ONE NONA PLAZA MULTIFAMILY

SUMMARY

<p>Owner One Nona Plaza, LLC</p> <p>Applicant Jeffrey Swisher, P.E. Kimley-Horn</p> <p>Project Planner Yolanda Ortiz , Planner II</p> <p>Updated: 3/2/23</p>	<p>Property Location: The subject property is generally located north of Tyson Rd., east of Narcoossee Road, and south of Vickrey Pl. and consisting of ±7.3 acres; addressed as: 12575 and 12591 Narcoossee Rd. (PID: 20-24-31-0000-00-011&012 &016); District 1.</p> <p>Applicant's Request: Master Plan for the development of 282 multifamily dwelling units.</p>	<p>Staff's Recommendation: Approval of the request, subject to the conditions in this staff report.</p>
---	---	--

Staff recommends approval of the MPL2023-10001 subject to the conditions below:

SITE PLAN

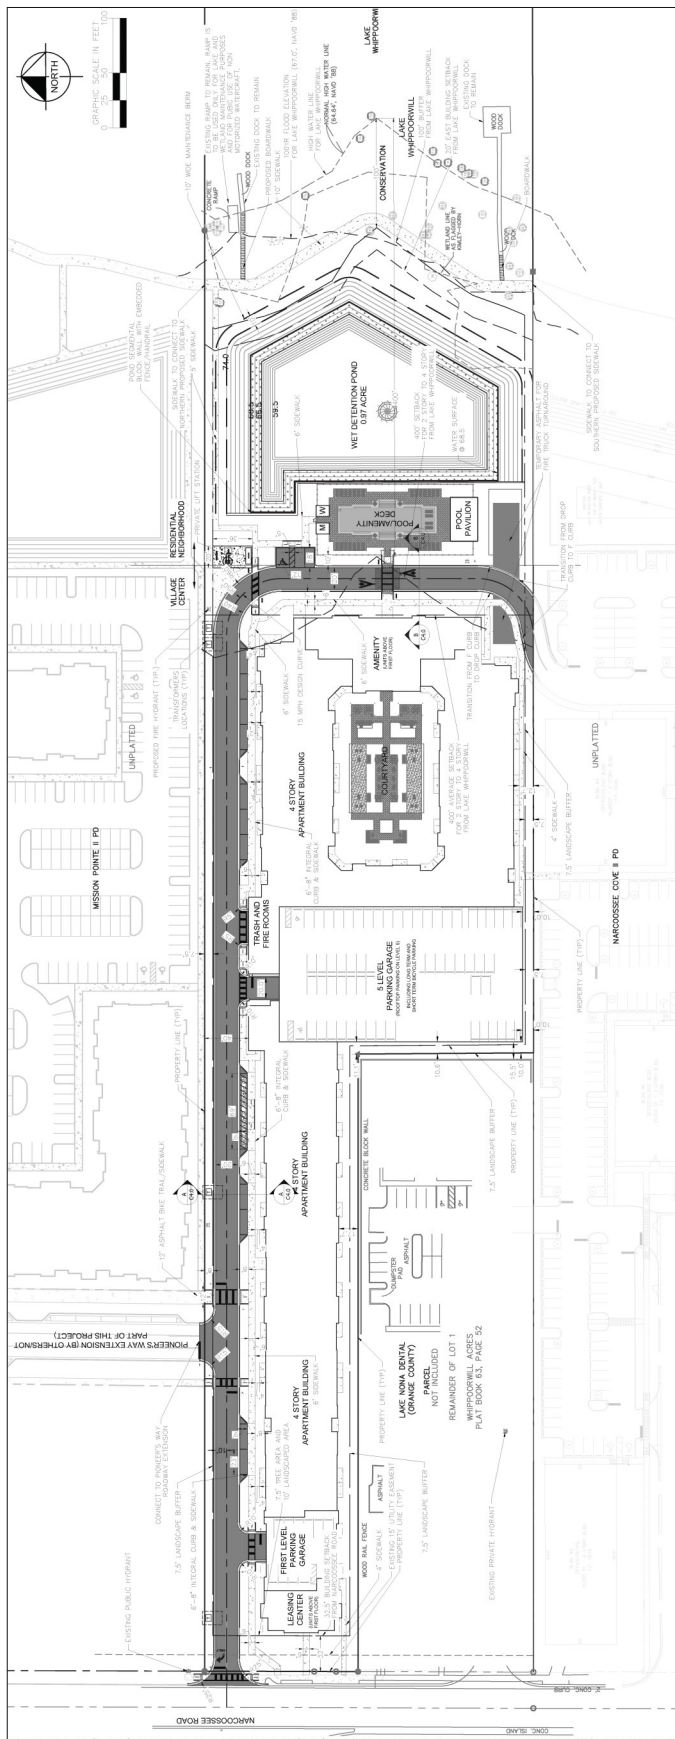
Regarding parking, the proposal is for the provision of 430 parking spaces of which 423 are required. See Table 4 for the details. The applicant is requesting to locate 47 spaces on the roof top deck of the parking garage and 37 spaces will be located on the ramp from level 4 to the top deck. Staff recommends approval of this request as an alternative standard, subject to compliance with all the screening and lighting conditions of approval for the garage, on the Urban Design section of this staff report.

ELEVATIONS

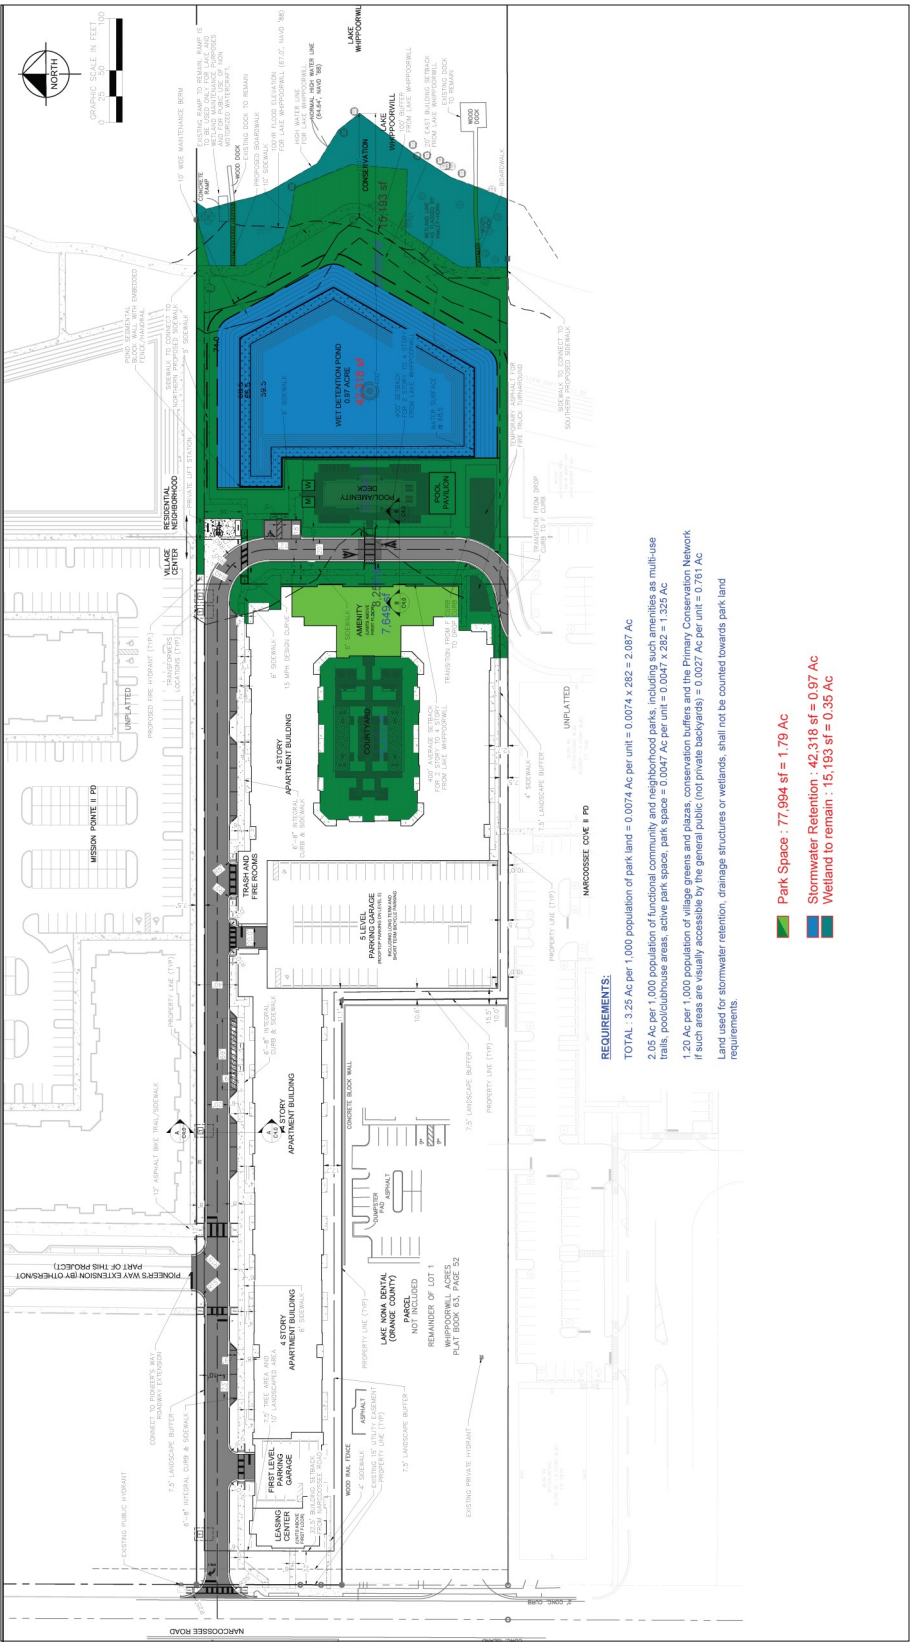
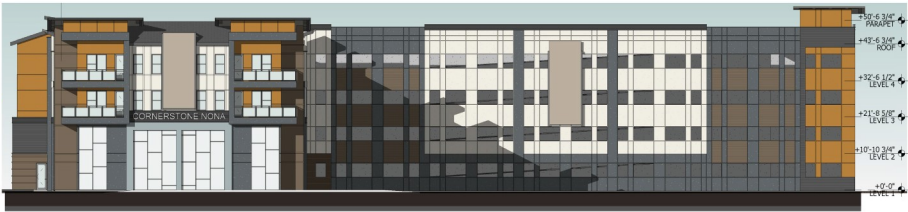
1. Architectural finishes and details must be carried through on all sides of the building. The bases of buildings should be designed with durable materials to provide a quality pedestrian experience. Stucco/EIFS is not an acceptable base material.

2. Canopies or sheltering elements must be used along active street fronts to provide pedestrian protection from the elements as well as interior primary pedestrian entrances into the building. Entrances must be clearly defined and articulated. It's currently, unclear where the primary entrances are.

7. The corners of the building along Narcoossee Rd. and the corners that frame the garage shall act as design elements. Additional height and articulation must be added to increase the skyline variations and to better define the mass and extent of the building.
8. A flat roofline is prohibited. Additional height and articulation is needed roughly every 60 ft. to break up the roofline.
9. All dumpsters and trash compactors must be screened with solid walls to match the principal structure. Decorative gates must be installed to coordinate with the principal structure. A Landscape screen including low hedge and groundcover is required to soften the view.
10. If an onsite lift station is proposed, the same level of screening is required for the lift station as is being provided for the dumpster.
